## BRENT SPENCE BRIDGE REPLACEMENT/REHABILITATION PROJECT

ODOT Project HAM-71/75-0.00/0.22, PID 75119
KYTC PROJECT ITEM NO. 6-17
Project Development Process Step 6

## FINAL - Value Engineering Study Report

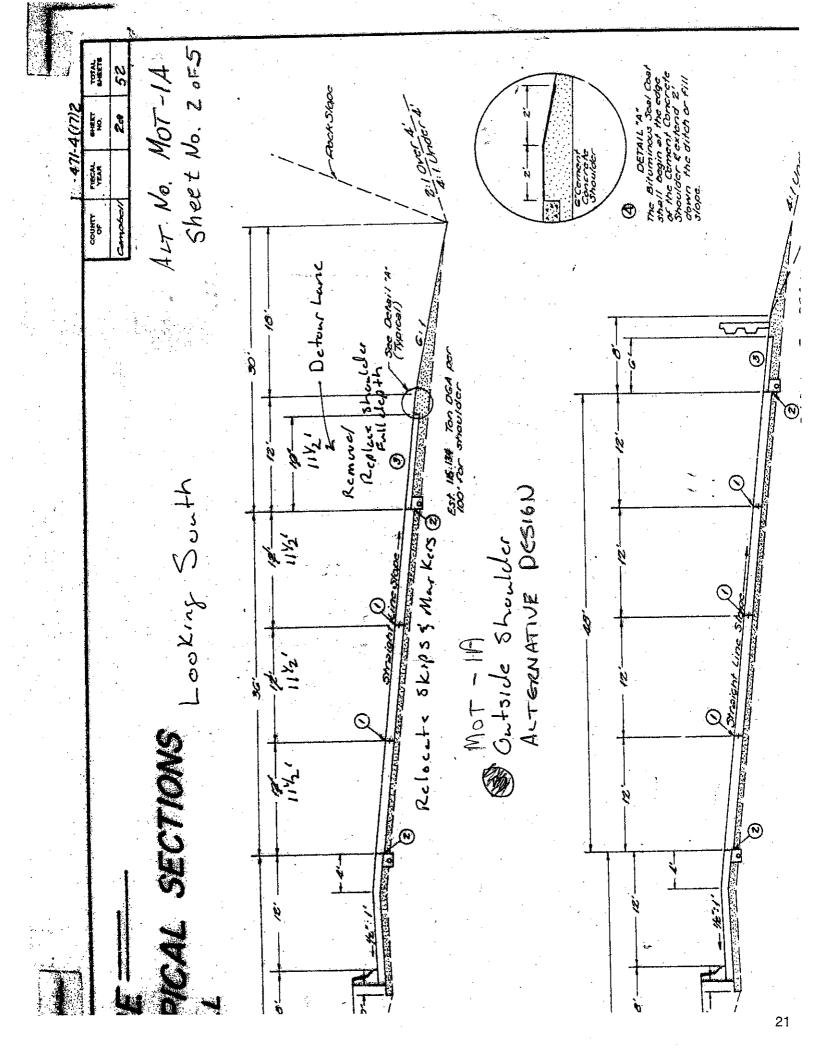
Replace the outside shoulders on I-471 Southbound with full-depth pavement to support rerouting of traffic during construction.

- Prevents shoulder failure during construction thereby preventing significant traffic delays
- Provides full-depth shoulders for any future construction requirements or detours

Added pavement adds cost to the current project for temporary lanes during construction

Replacement of the outside shoulders on I-471 Southbound with full-depth pavement will prevent the failure of shoulders during construction as well as provide additional capacity for future construction requirements or detours.

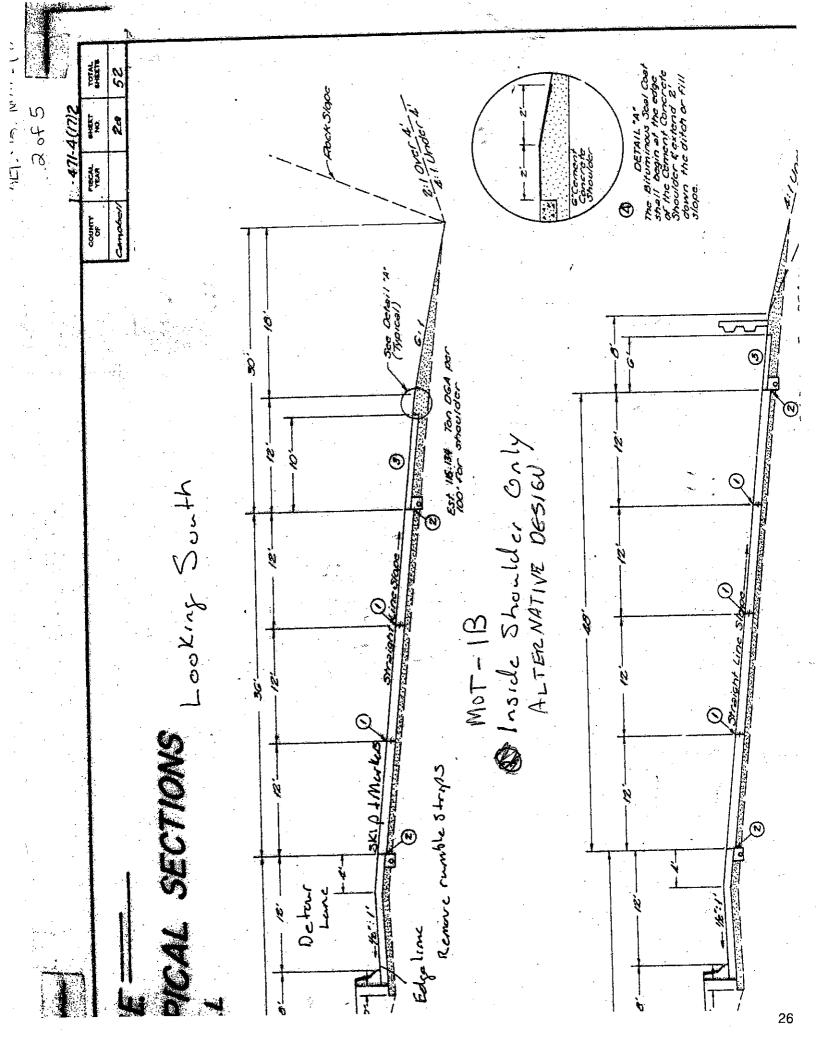
- No full-depth pavement replacement required
- Maintains 12-ft.-wide lanes during construction

- Requires travel near drainage structures
- No inside shoulder provided during construction

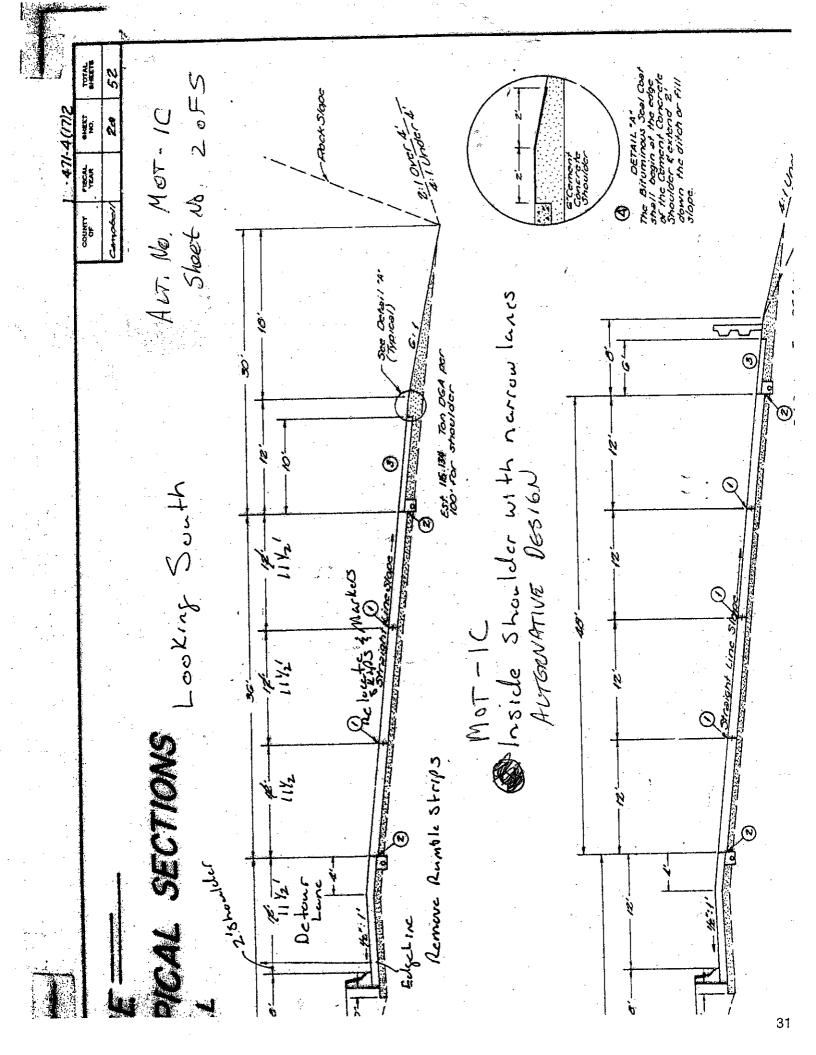
- No full-depth pavement replacement
- Maintains a 2-ft.-wide inside shoulder

Narrower travel lanes are necessary to accommodate the 2-ft.-wide inside shoulder

ORIGINAL DESIGN ALTERNATIVE DESIGN

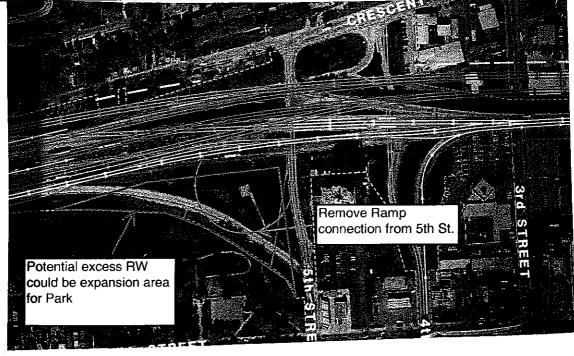
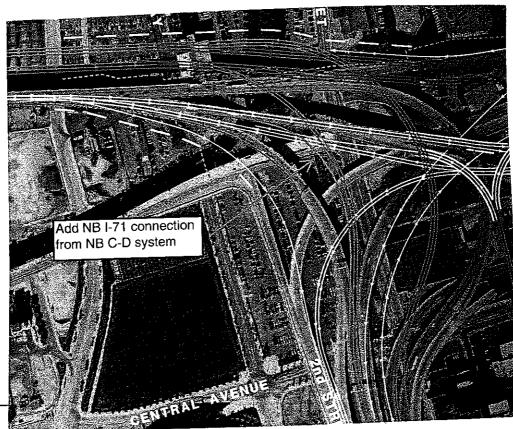
Remove the loop ramp at KY 5<sup>th</sup> Street and replace it with a ramp connection from the northbound collectordistributor roadway to I-71 northbound in Ohio.

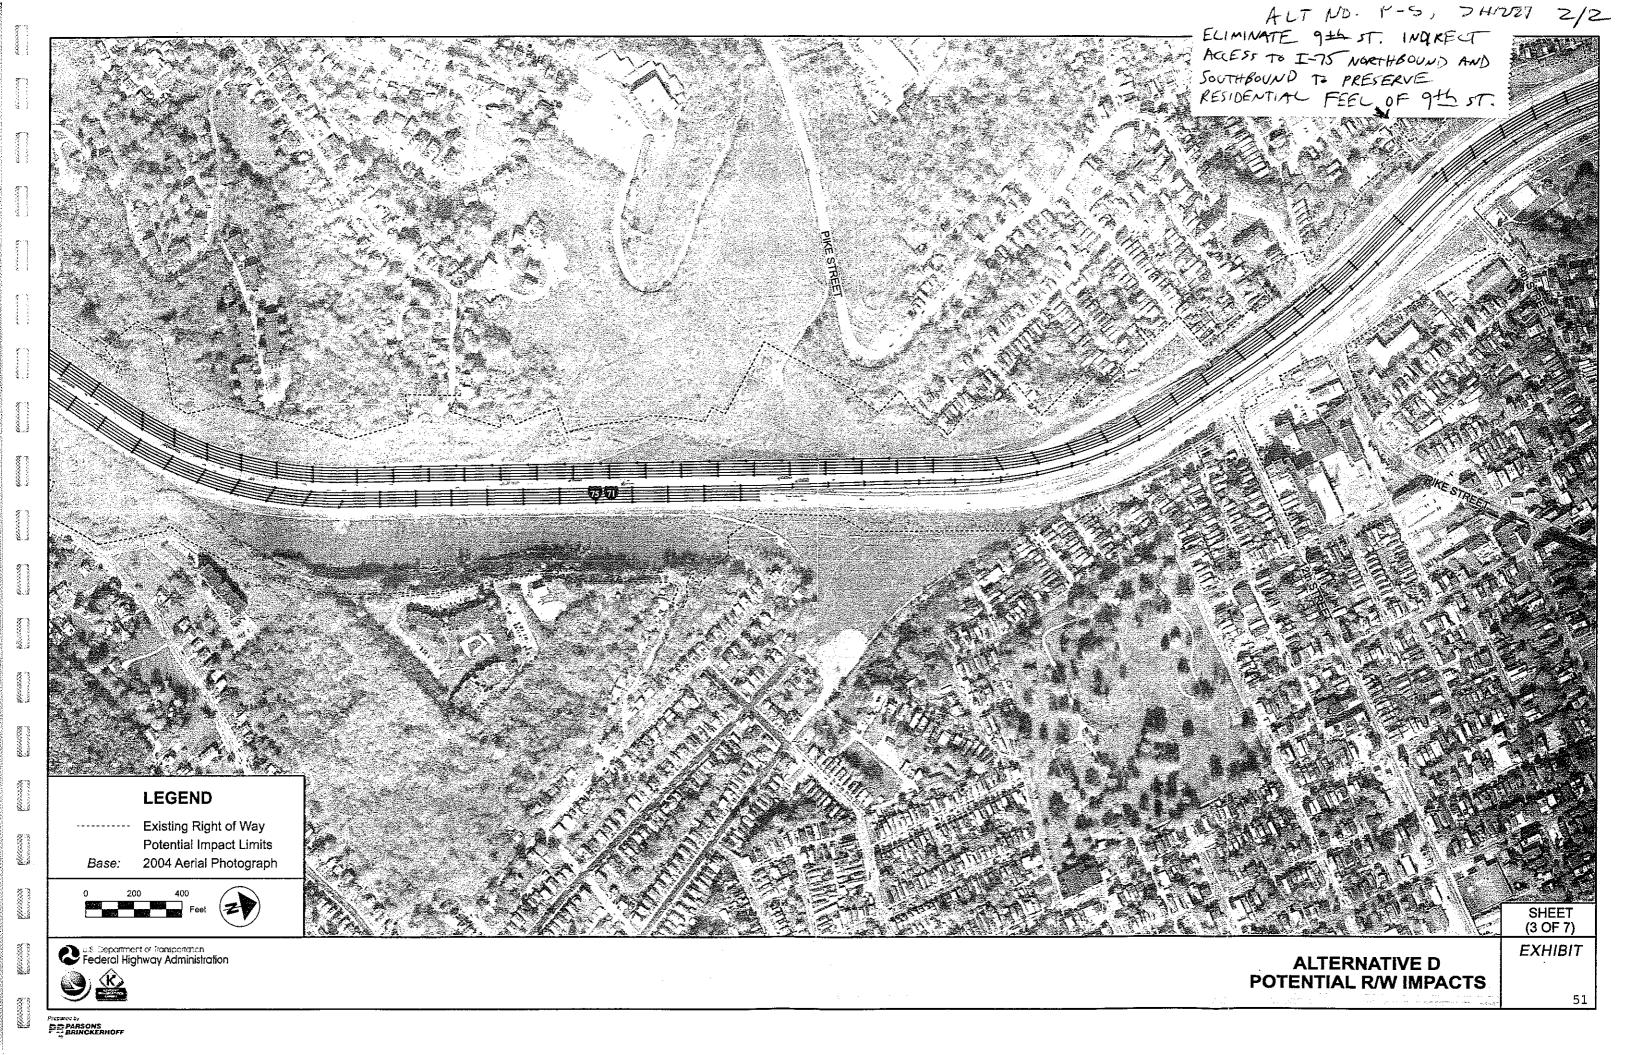
Currently, Hybrid Alternative CD, and Alternative E show the collector-distributor roadway intersecting with KY 9<sup>th</sup> Street on both sides of I-71/I-75.

- Neighborhood retains its appeal for the residents
- Improves level of service and operation of the collector distributor roadway
- Reduces access along KY 9th Street

- Eliminates an indirect access point for the City of Covington -
- 9th Street would likely have a dead end on both sides of I-71/I-75

SHEET NO.: 2 of 6

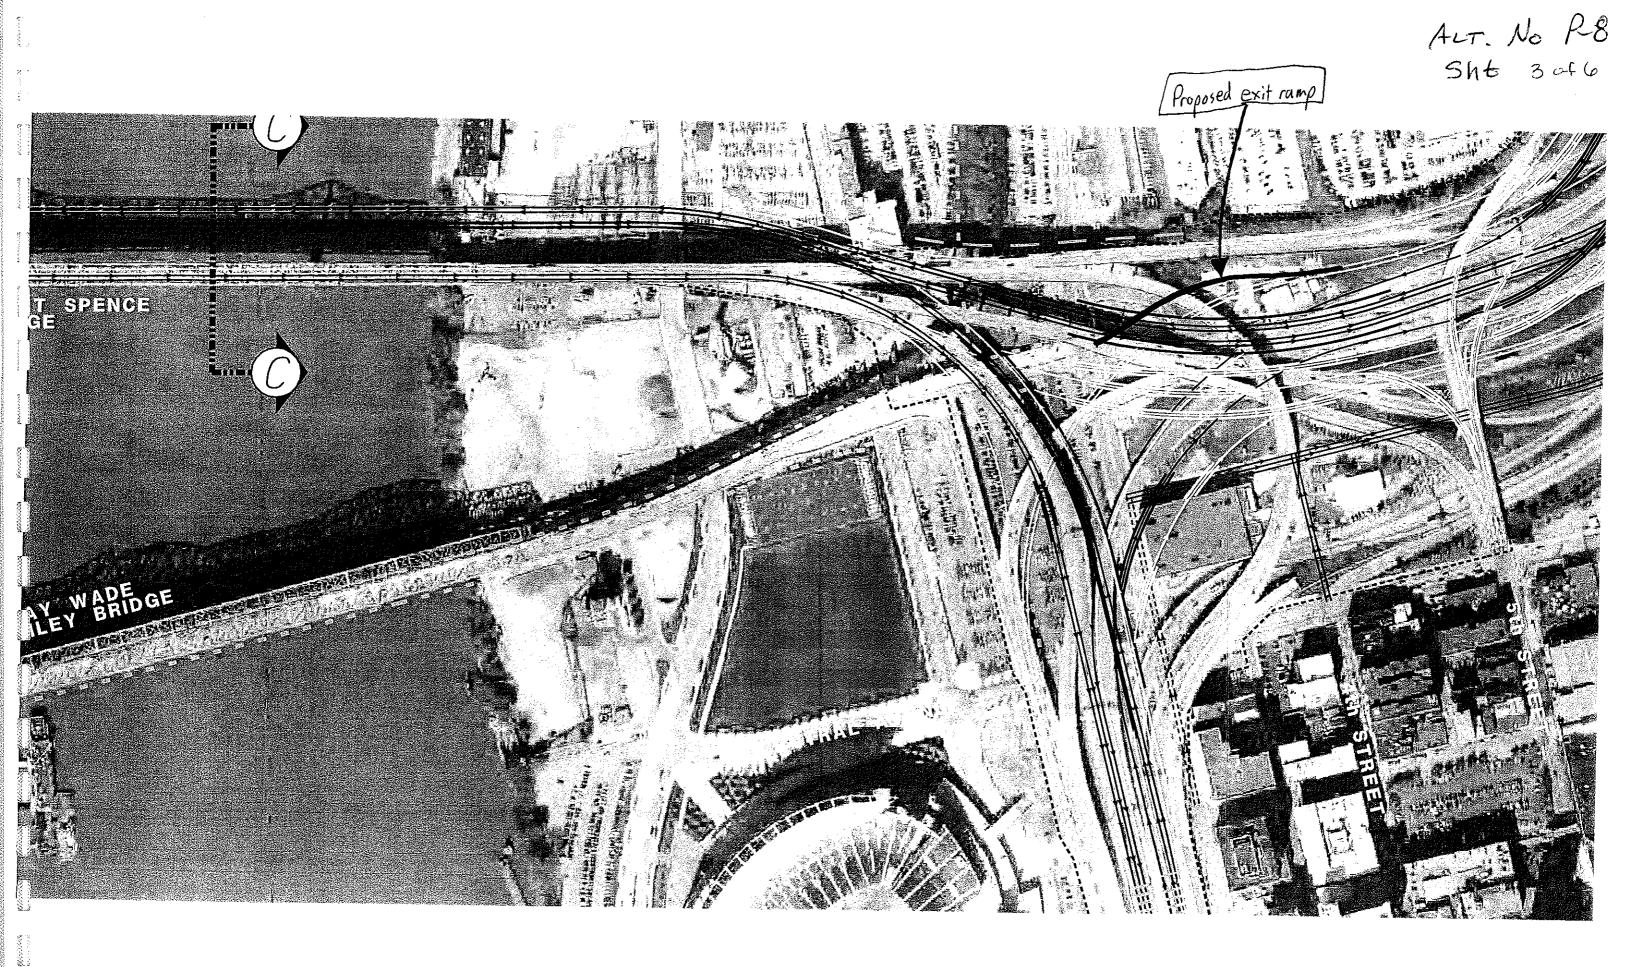
- The proposed ramp will add construction cost to the project
- The US 42/3<sup>rd</sup> Street intersection may need to be reconstructed to support the increased traffic volume
- The intersection on the Kentucky side of the Clay Wade Bailey Bridge may need to be reconstructed to support the increased traffic volume

The main reason for the addition of this ramp is to provide direct access from the southbound collector-distributor to the Clay Wade Bailey Bridge and take advantage of available capacity. Providing an alternative route across the Ohio River could reduce congestion on the existing Brent Spence Bridge as well as the proposed Ohio River Bridge. This ramp can also improve the functionality of the City of Cincinnati street grid.

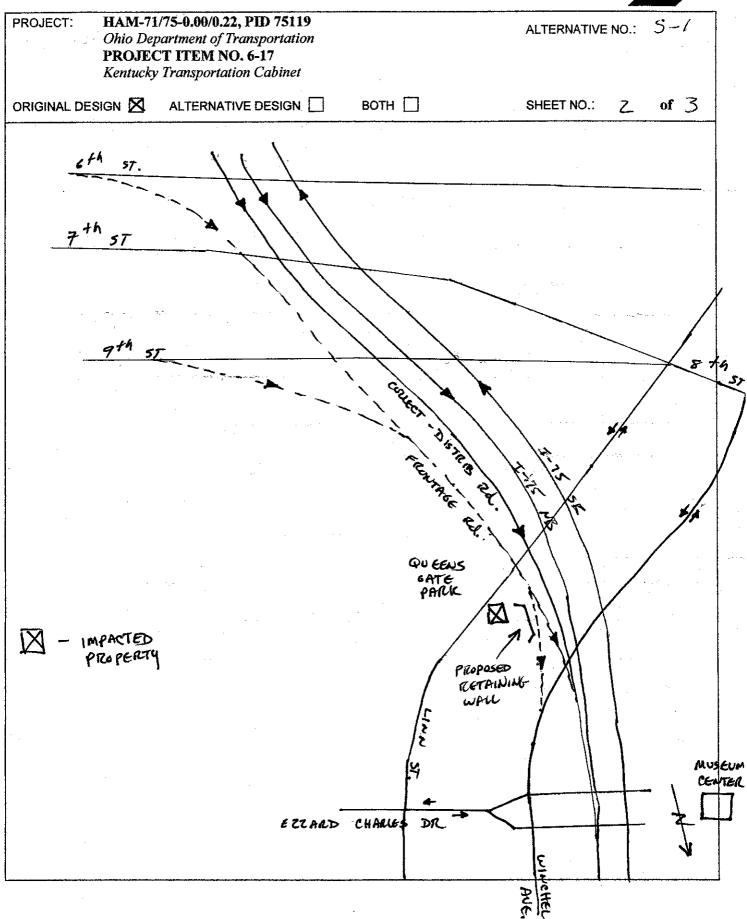
Add a drop lane from the collector-distributor roadway and merge this with the frontage road between 9<sup>th</sup> Street and Linn Street. This frontage road merges with Freeman Avenue and crosses Ezzard Charles Drive.

- This alternative would create a braided merge between the collector-distributor road and oncoming traffic from 6<sup>th</sup> Street and 9<sup>th</sup> Street
- A design exception may be required for the length of the collector-distributor roadway deceleration lane which requires 400 feet minimum

A certified travel analysis is recommended to determine the potential benefit of the proposed new exit. No additional right-of-way or retaining walls will be required other than what is already proposed for the Hybrid Alternative CD Frontage Road (i.e., Queens Gate Park). Utility and cultural impacts would remain unchanged also.

The design year average daily traffic (ADT) for the new collector-distributor roadway is 42,770 based upon Alternative C traffic data. The design year ADT for Winchell Avenue from 9th Street to Freeman Avenue is 10,520. An unknown percentage of collector-distributor traffic will be added to Winchell Avenue.

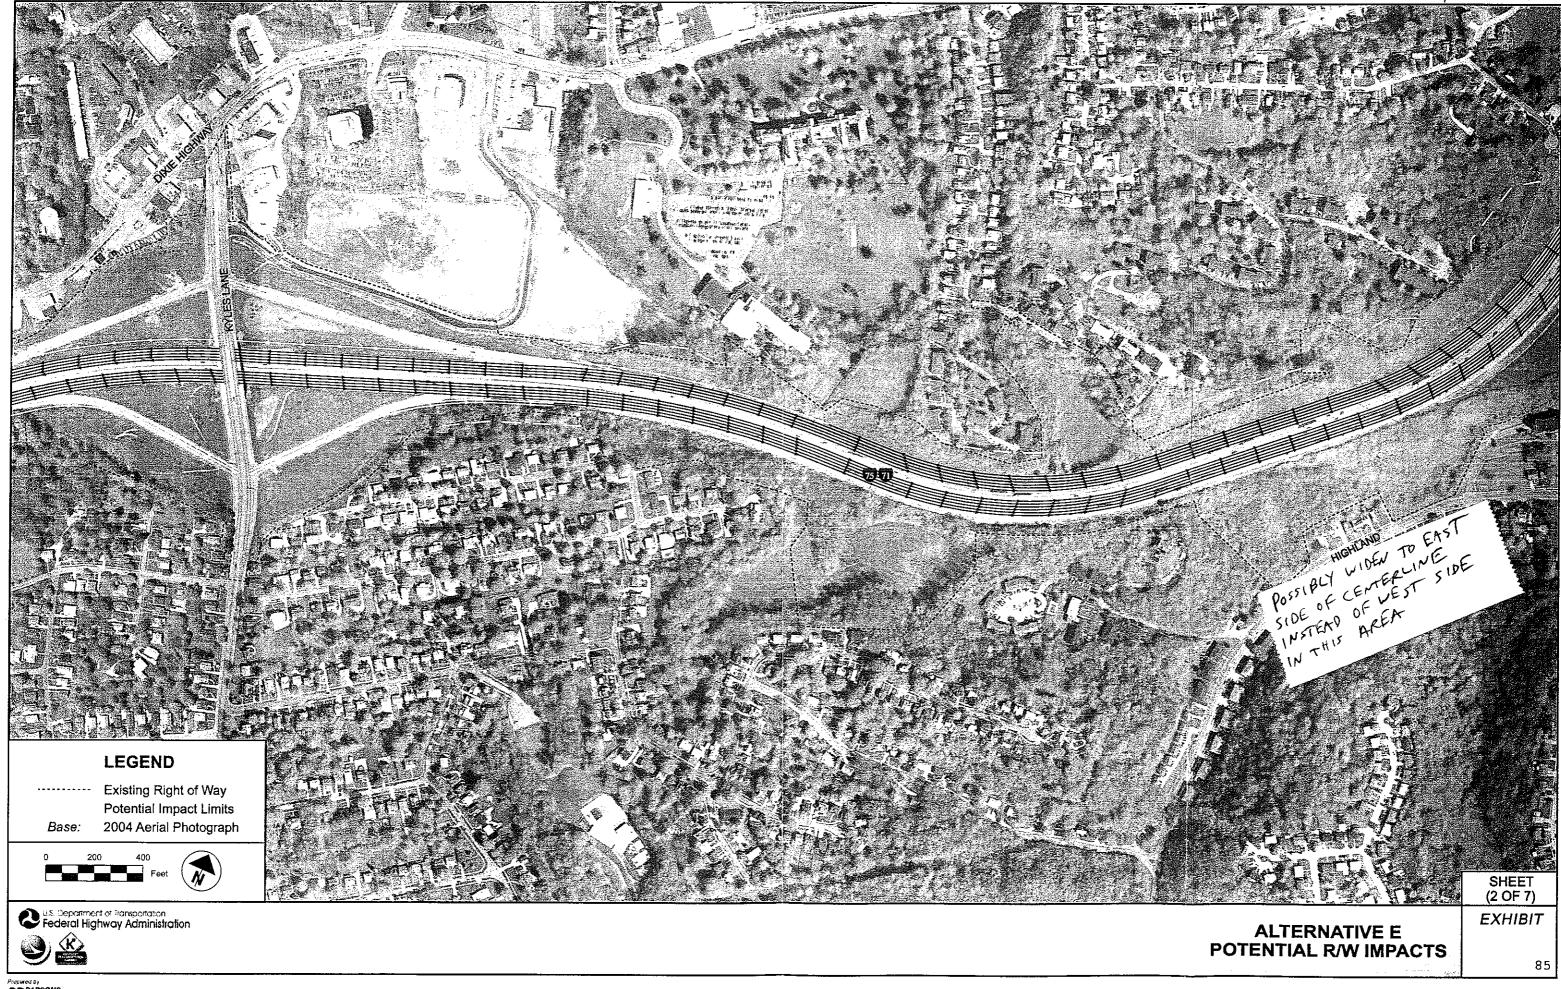
- Eliminates expensive walls on west side in "Hill" section
- Better use of existing right-of-way
- · Less disruption to existing storm facilities

- Maintenance of traffic becomes more complicated because Stage 1 work is now on both sides of the interstate
- Highland Avenue section has slope stability and flooding issues
- Geometry may be less desirable with the new hospital, now a restriction at the northern end
- May interfere with the proposed light rail corridor
